**APPLICATION OF TRI TRY WATER
SUPPLY CORPORATION TO
OBTAIN A WATER CERTIFICATE
OF CONVENIENCE AND
NECESSITY IN STONEWALL
COUNTY**

**COMMISSION STAFF'S SECOND SUPPLEMENTAL RECOMMENDATION ON
ADMINISTRATIVE COMPLETENESS, NOTICE, AND PROCEDURAL SCHEDULE**

Subject: *Docket No. 50042, Application of Tri Try Water Supply Corporation to Obtain a Water Certificate of Convenience and Necessity in Stonewall County*

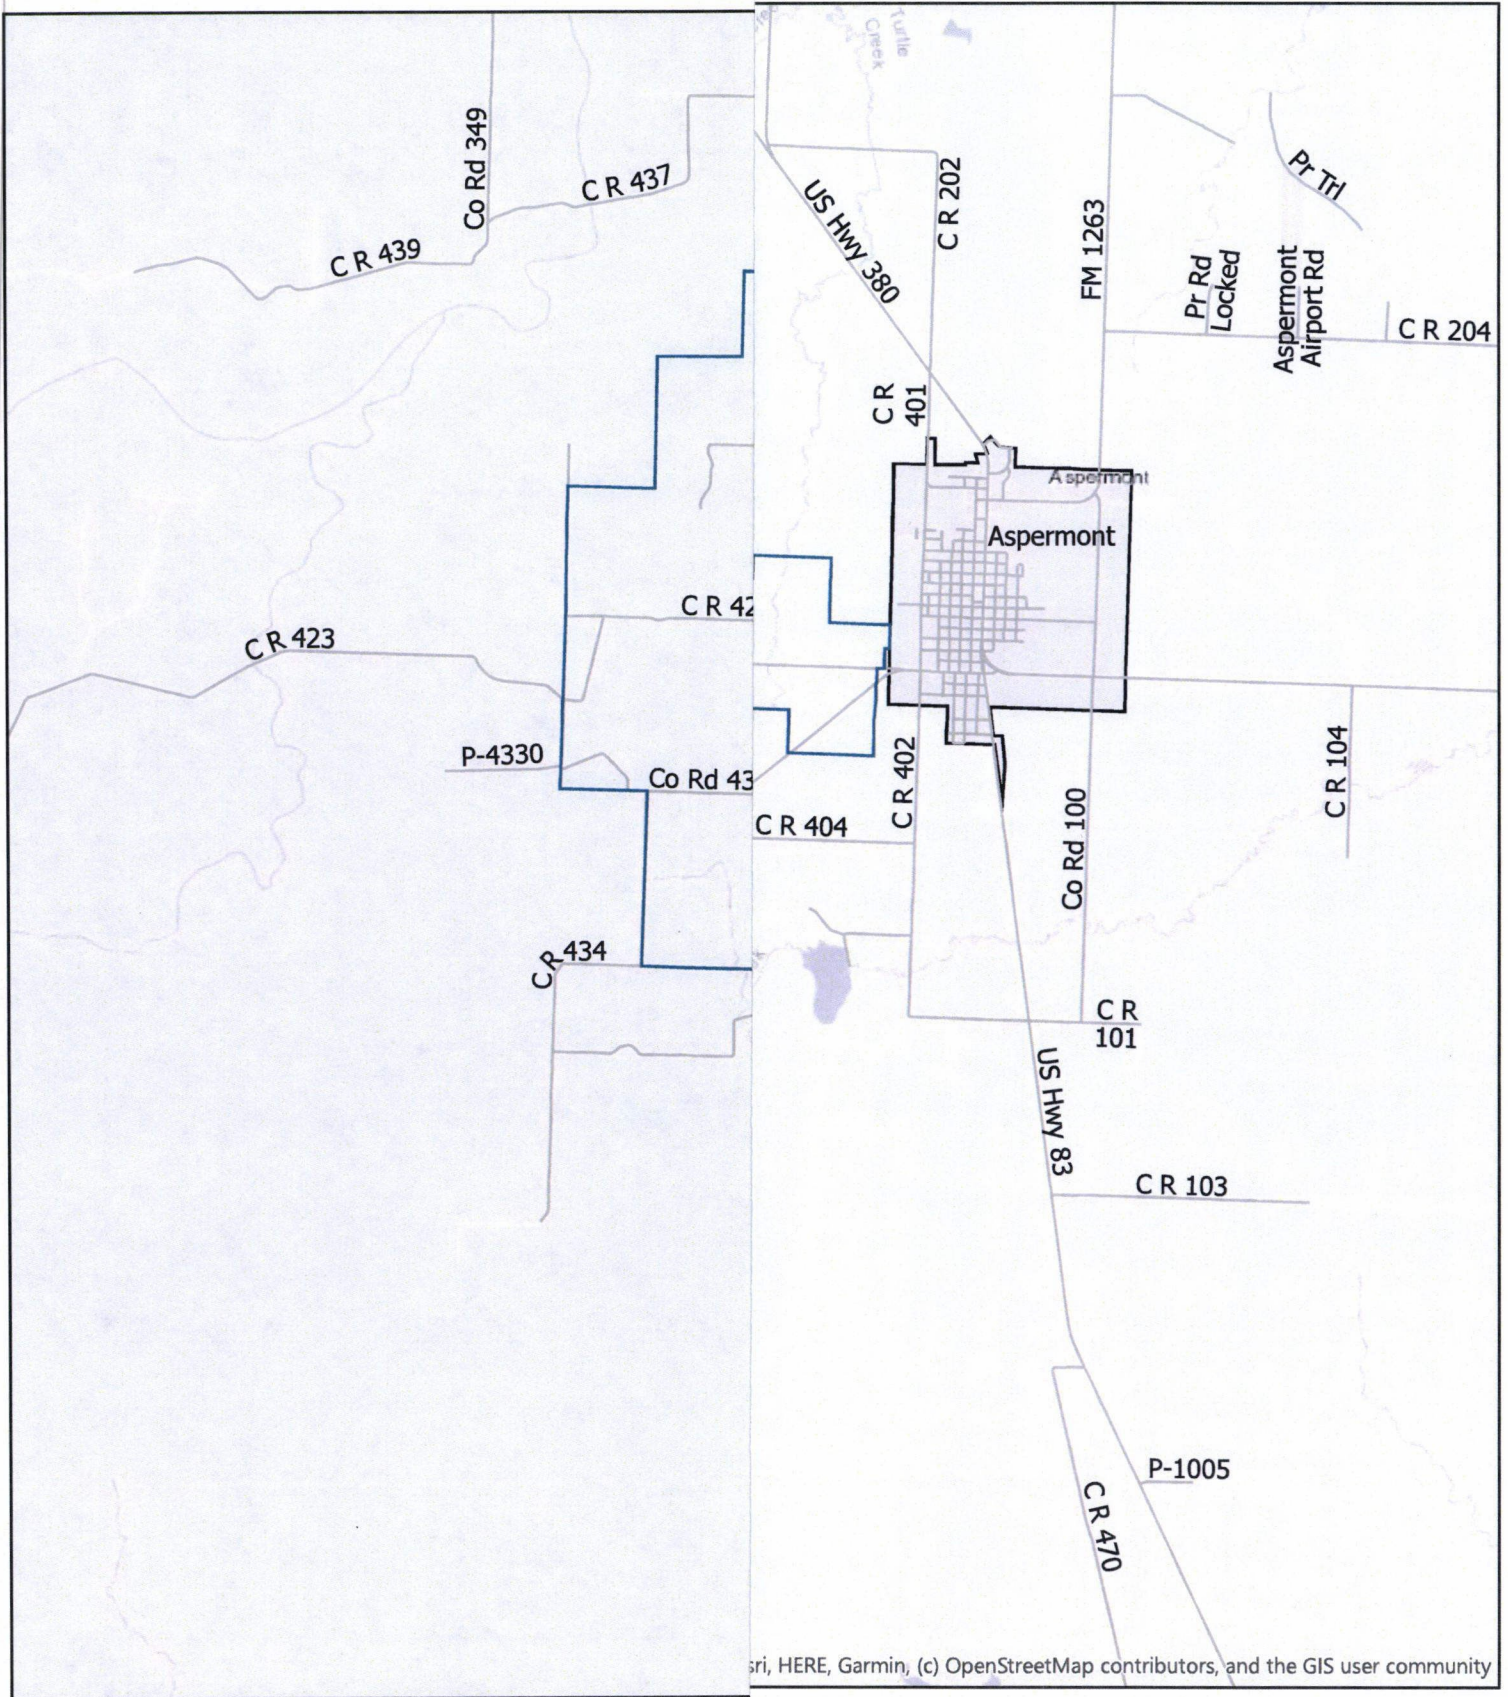
The Applicant's detailed map filed on January 23, 2020 is deficient. The detailed map does not show roads and streets located inside and outside the outer boundary of the requested area.

In order to resolve the mapping deficiency, the Applicant must submit a revised detailed map identifying only the requested area, in reference to verifiable man-made and natural landmarks, such as roads, rivers, and railroads.

Attachment #2 – Updated Detailed Map

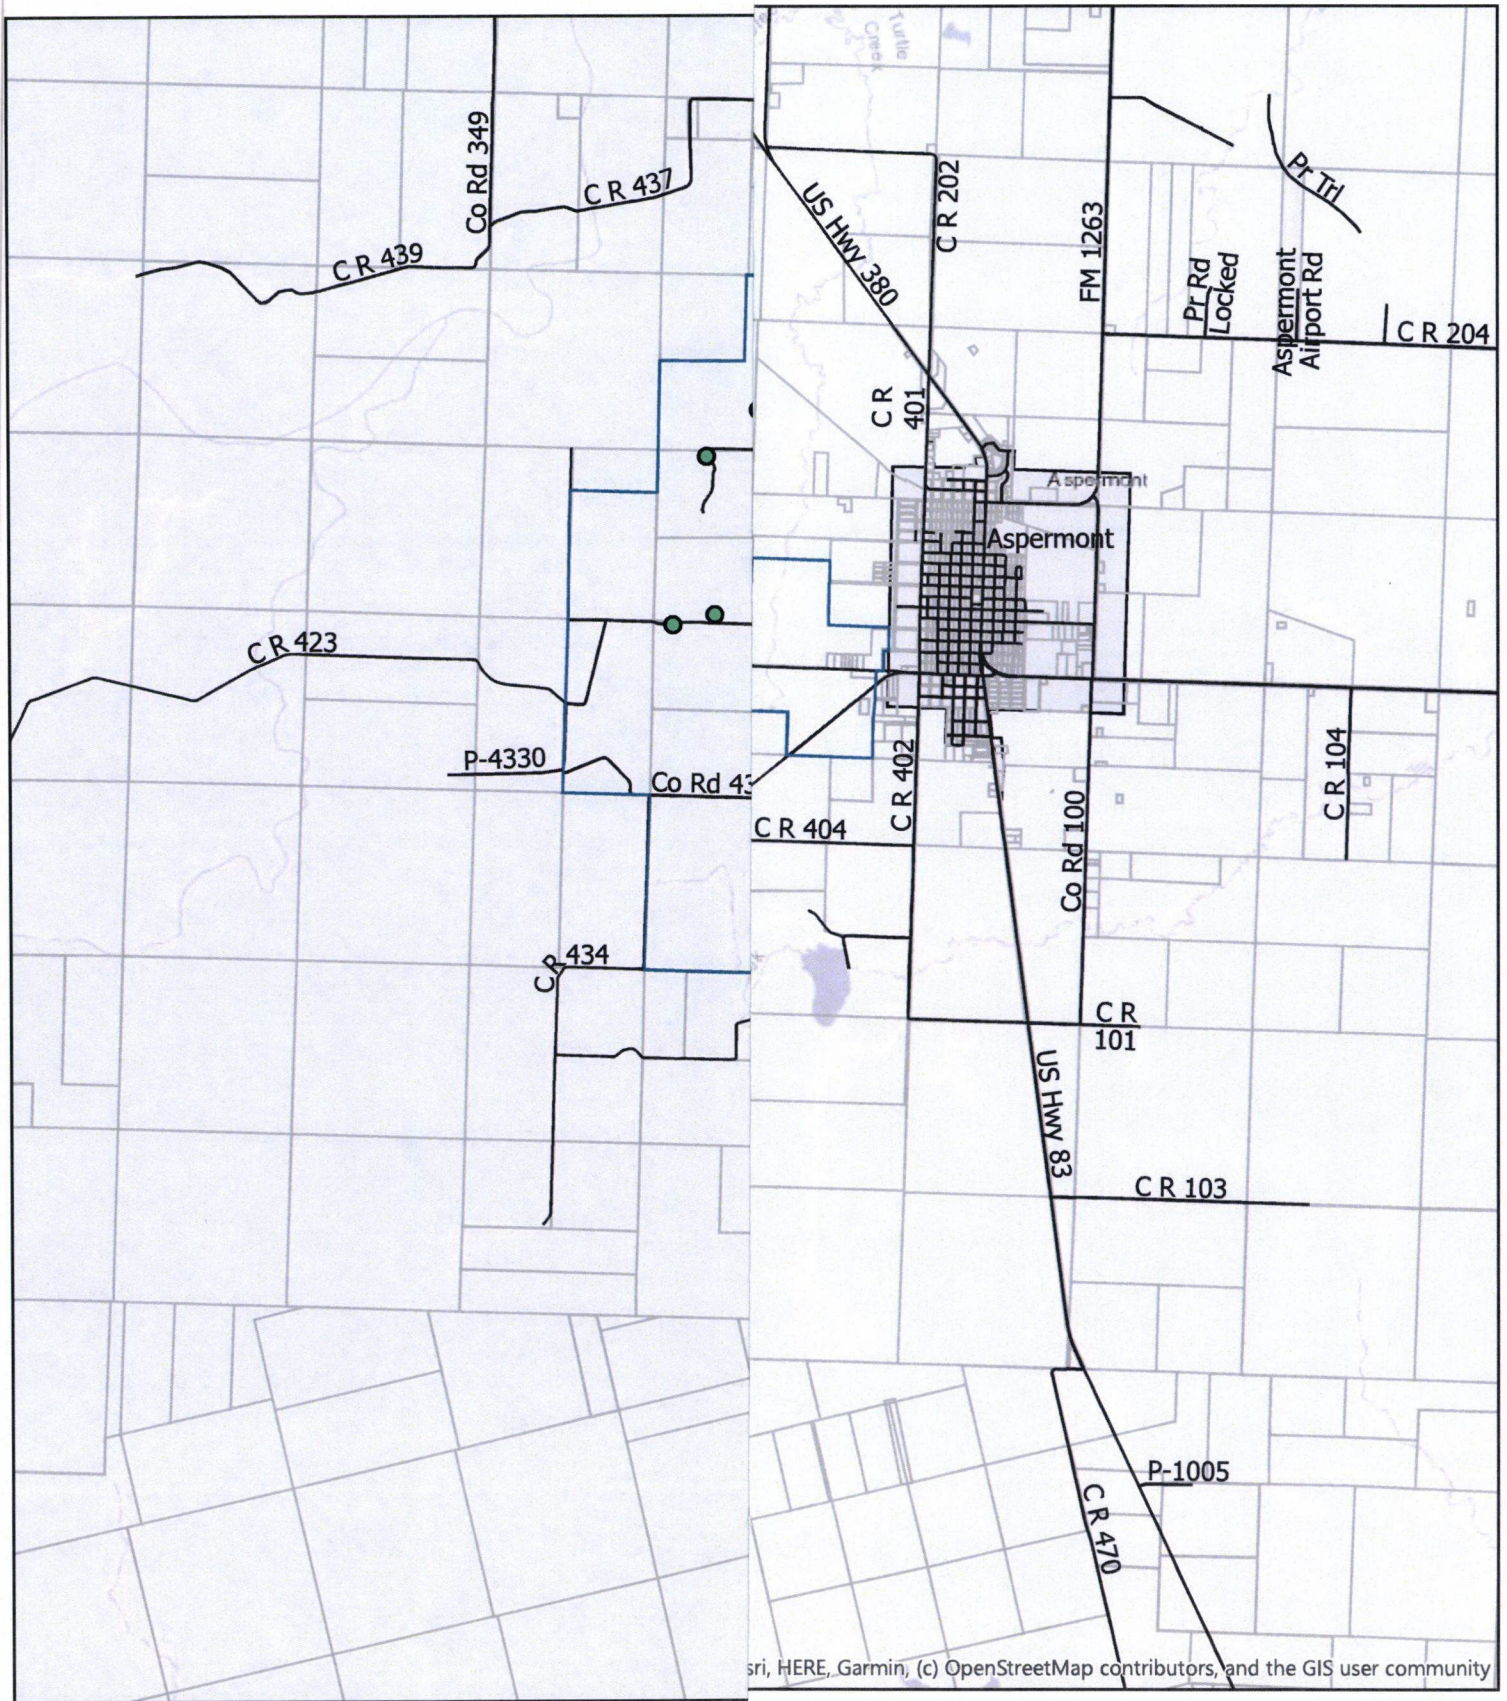
1. Provide a detailed map identifying the existing facility lines located within the requested area and show the parcel boundaries in reference to verifiable man-made and natural landmarks, such as roads, rivers, and railroads.
2. As required by 16 TAC § 22.72(k), electronically upload a PDF for each map used to respond to the maps requested above, in the following forms:
 - a) Hard color copy, full-sized, and rendered to scale; and
 - b) Electronically file a color copy, in an Adobe PDF file format, in the Commission's Interchange Filer.
